Elements supporting ECE/TRANS/WP.29/GRVA/2022/11

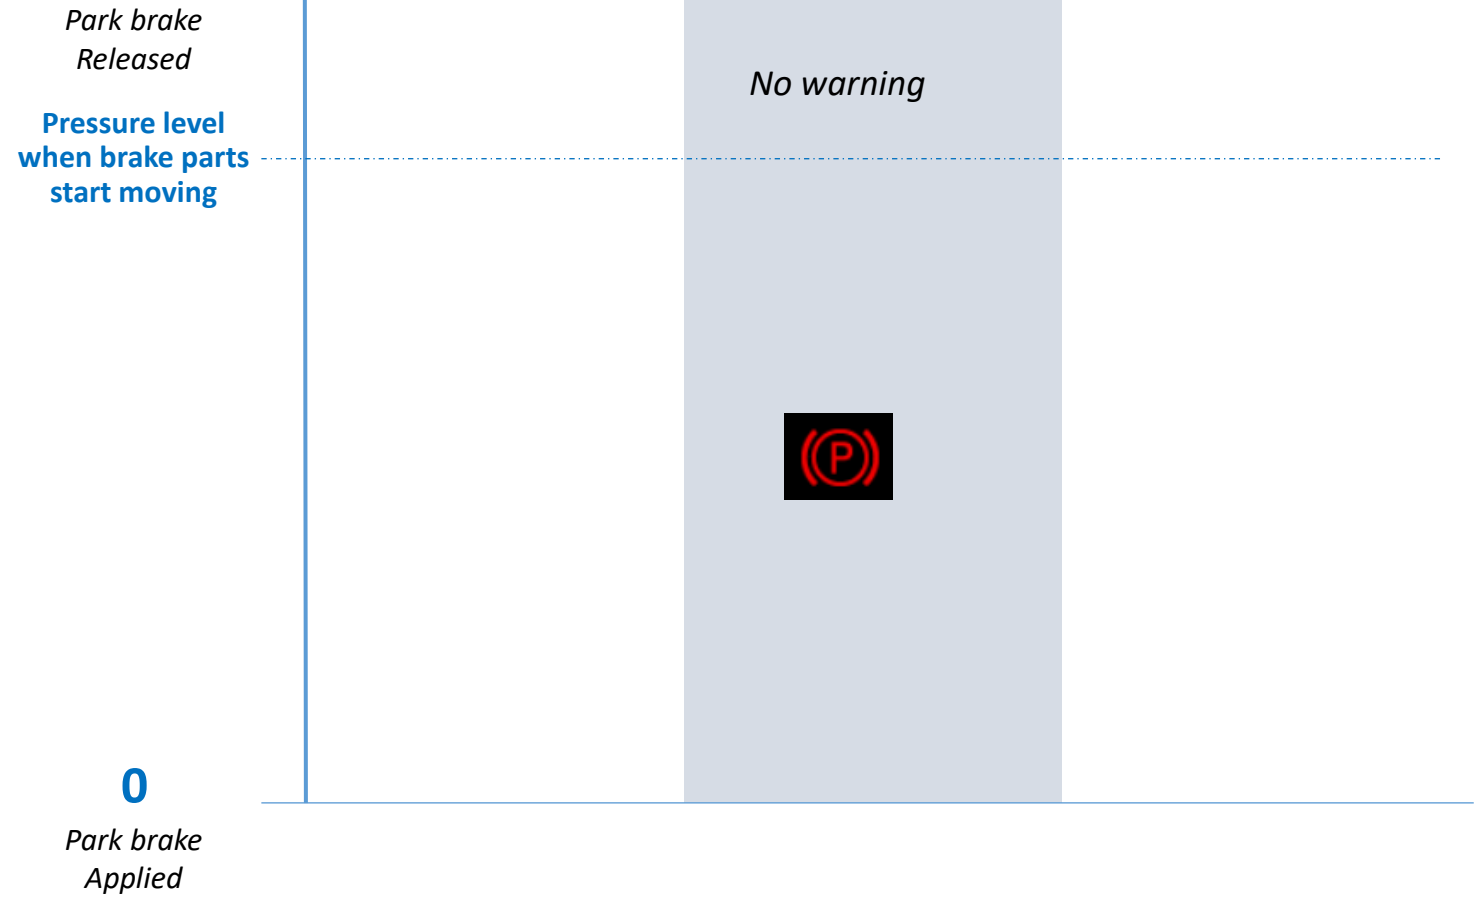
Insert new paragraph 5.2.1.26.5., to read:

“5.2.1.26.5. If the parking braking system detects a request (generated automatically or by the driver) to apply the parking brake, the actuation of the warning as required in-paragraph 2.6. of Annex 8 may be delayed until the parking brake is in a stable state.”
